Your Ref: N/A
Our Ref: qA1316455 / R0040
Date: 12 February 2020

A40 LLANDDEWI VELFREY TO PENBLEWIN IMPROVEMENTS

Drawing A40LVP-ARP-HER-SWI-DR-LH-0002 – Impact of the Scheme of Blaen-Pentroydin Wood

Drawing Title
IMPACT OF SCHEME ON BLAEN-PENTROYDIN WOOD

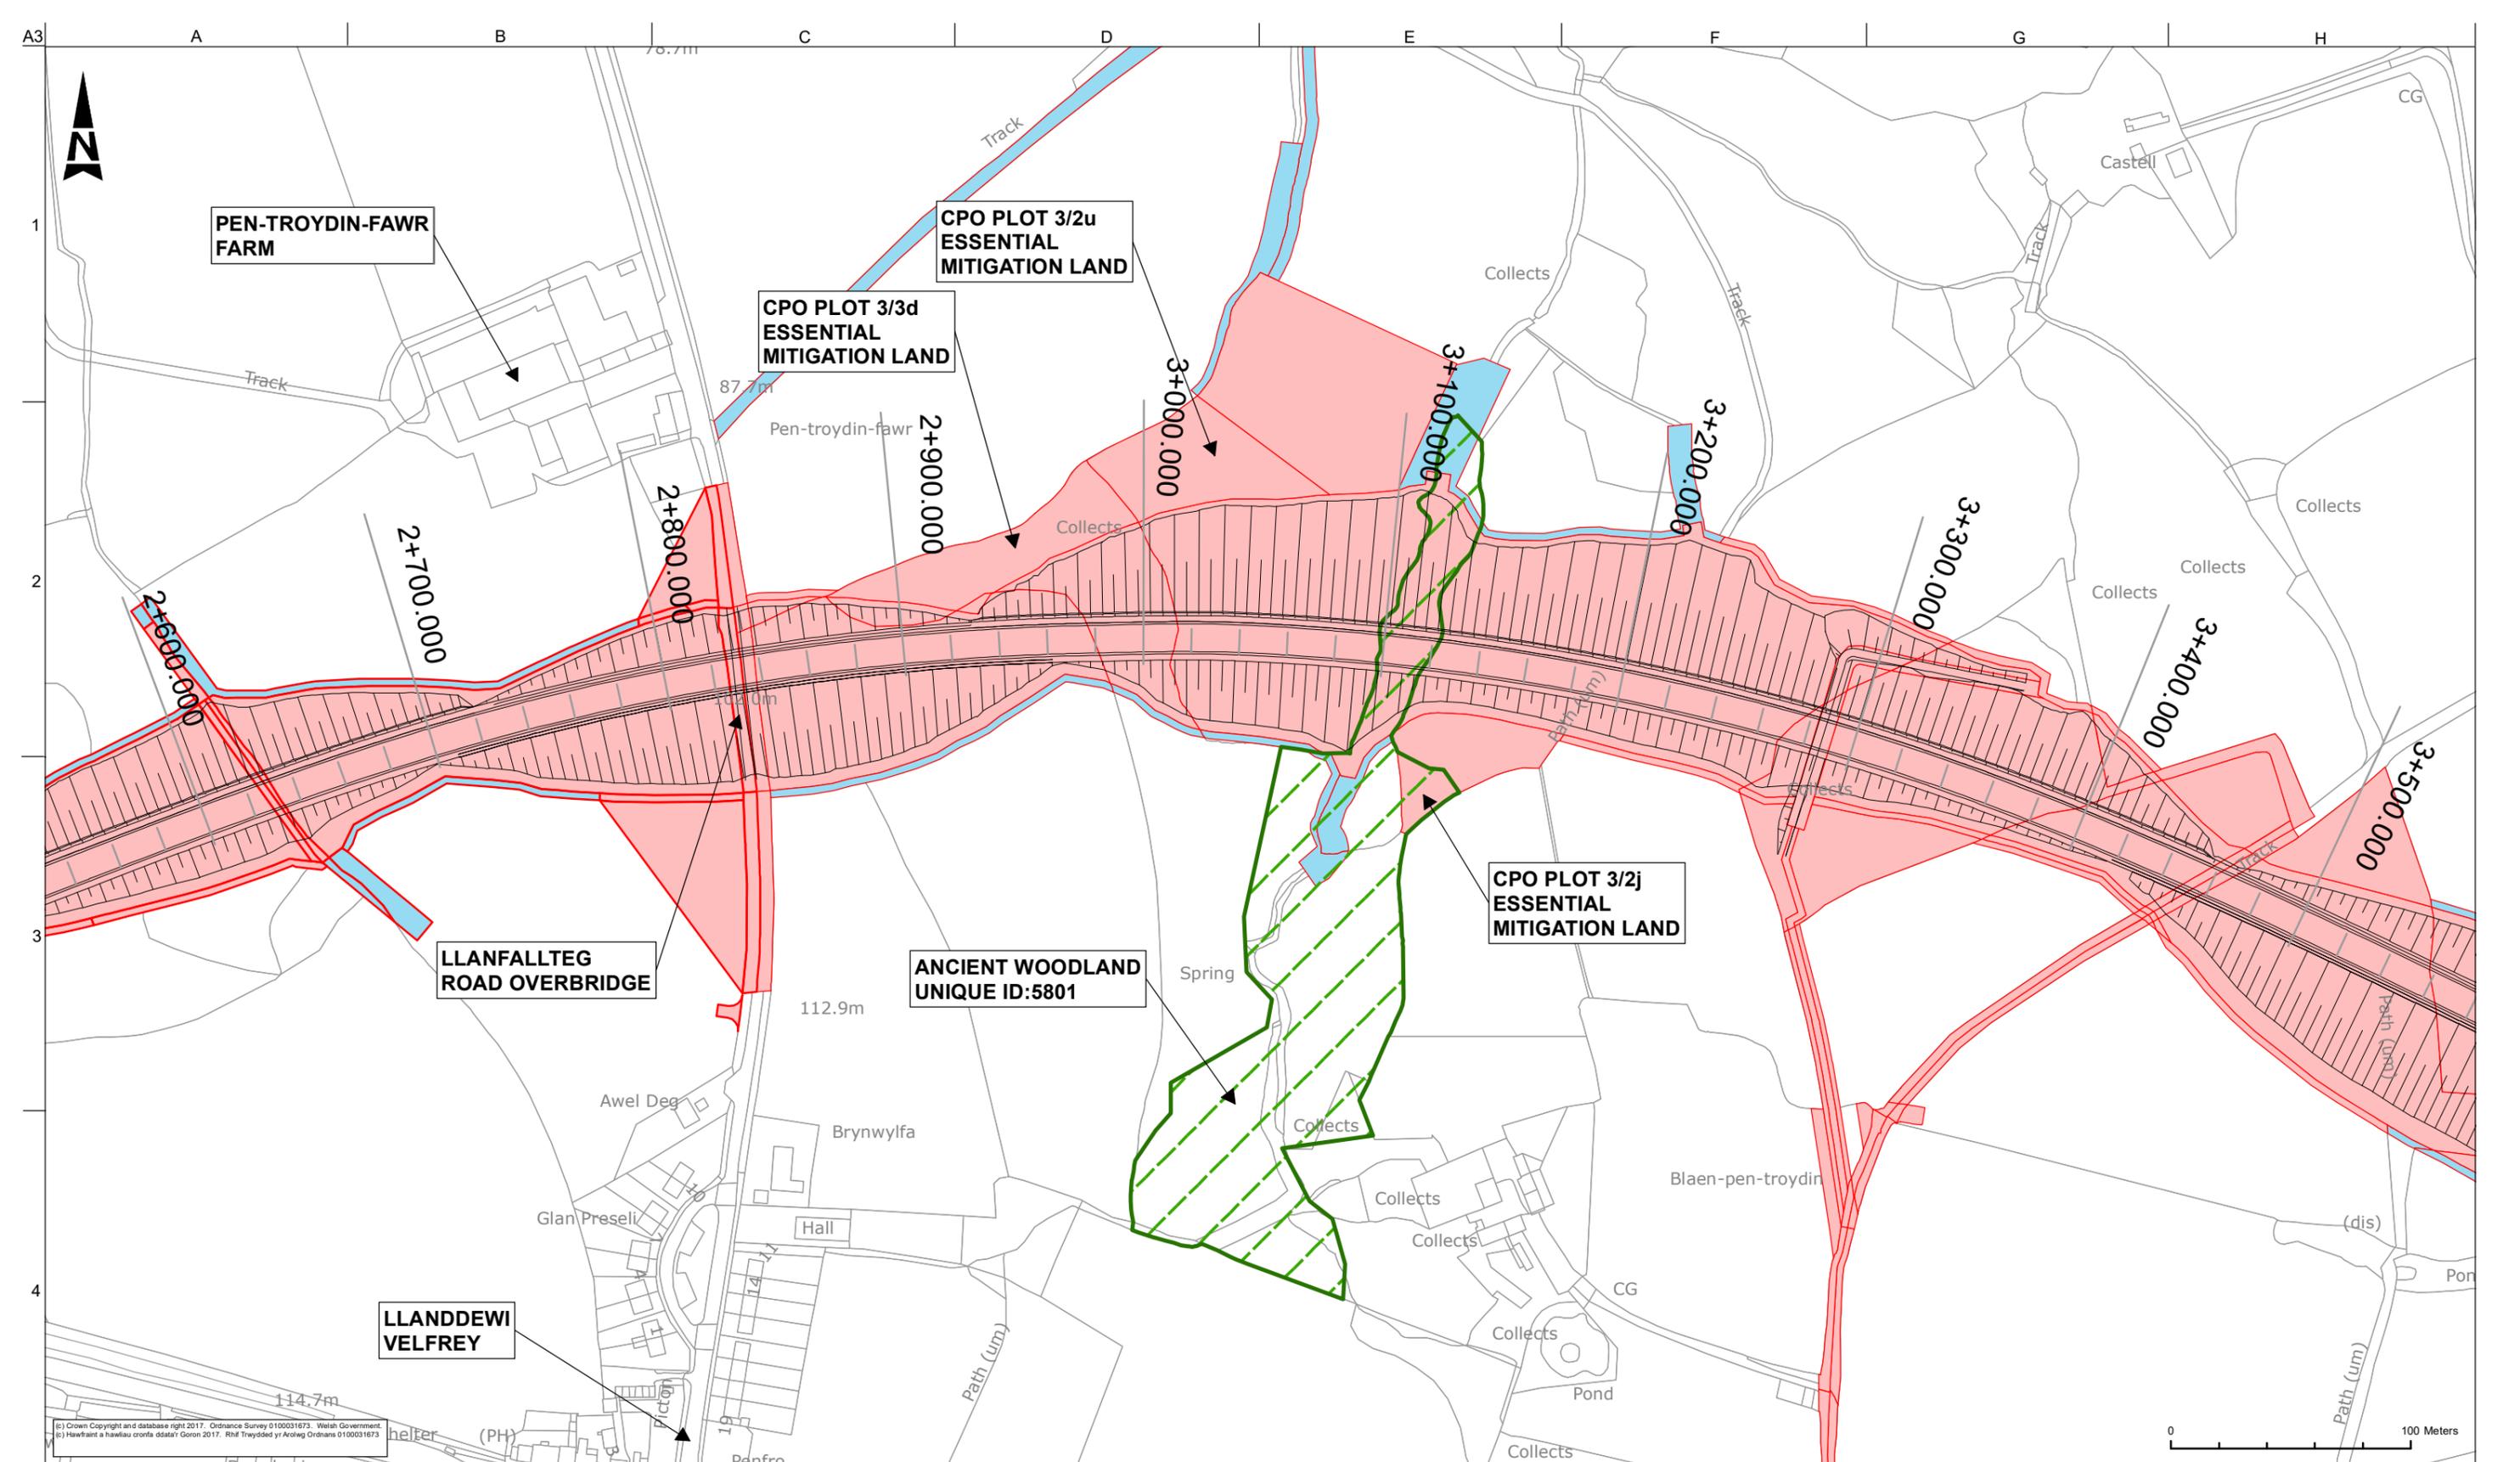
4. Unacceptable damage to ancient woodland north of Llanddewi Velfrey;

- 4.1 The wood at Blaen-Pen-Troydin is an area of Restored Ancient Woodland and is associated with the small valley of a minor watercourse. Clearance of a strip through this woodland is proposed to provide space for the road on an embankment. The extent of the clearance is shown in the ES Volume 3 Appendix 2.5, Environmental Masterplan, Sheet 5. I also enclose drawing A40LVP-ARP-HER-SWI-DR-LH-0002 to display the extent of this area and the Scheme proposals.

- 4.2 During route selection for the improvement scheme the proposed route was initially selected to minimise damage to the woodland but was subsequently realigned to the north to reduce damage further. The original vertical alignment was then reduced so that the embankment would be less high and less wide, and the overall width of land taken was minimised. Both these measures reduced the area of woodland required to be cleared to construct the Scheme by approximately 50%.

- 4.3 The reduced area of Restored Ancient Woodland clearance would occur where the designated area is a narrow finger of trees extending north from the main block of Ancient Woodland. Consequently, an area of approximately 0.18 hectares would be cleared, and the northern end of the finger would be severed. During route selection an alignment further to the north, to avoid the woodland altogether, was considered. However, this would result in the loss of other habitats, more significant adverse impact on farm businesses, and more harsh landscape and visual impact from the high embankment.

- 4.4 PPW10 paragraph 6.4.26 advises that such woodland areas should be protected from development unless there are significant public benefits. In view of its significant public benefits the Scheme accords with national planning policy regarding ancient woodland in PPW10.
